ADA Compliance Program

Clark County Facilities Transition Plan Clark County Juvenile Justice Center

Date of Survey: March 27, 2006
 Conducted by: Clark County Citizen ADA Advisory Board

Fig. 307.2
Limits of Protruding Objects

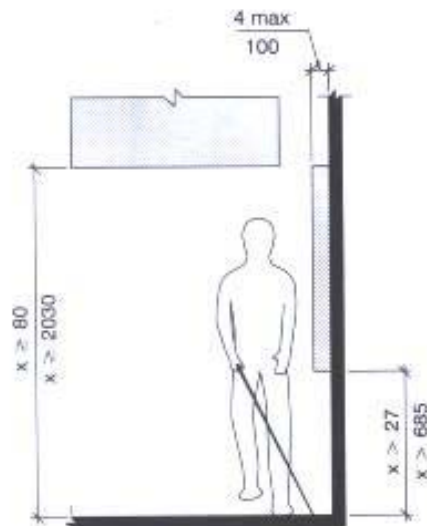
Item: Telephone – 1st Floor Lobby – Protrusion Limits

ANSI 307.2 Protrusion Limits. Objects with leading edges more than 27 inches and not more than 80 inches above the floor shall protrude 4 inches maximum horizontally into the circulation path. The drinking fountain shown protrudes 11 inches and the height shown is 32 3/8 inches.

The telephone should be recessed into an alcove.

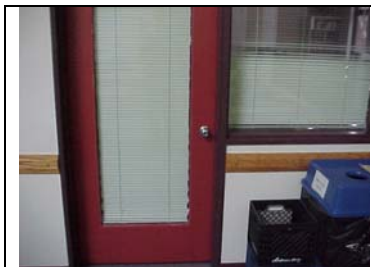
Item – First Floor Accessible Restroom – Flush Handle Location

ANSI 604.10.6 - Flush Controls - Flush controls shall be hand operated or automatic. Hand operated flush controls shall comply with Sections 309.2 and 309.4 and shall be installed 36 inches maximum above the floor. Flush controls shall be located on the open side of the water closet.
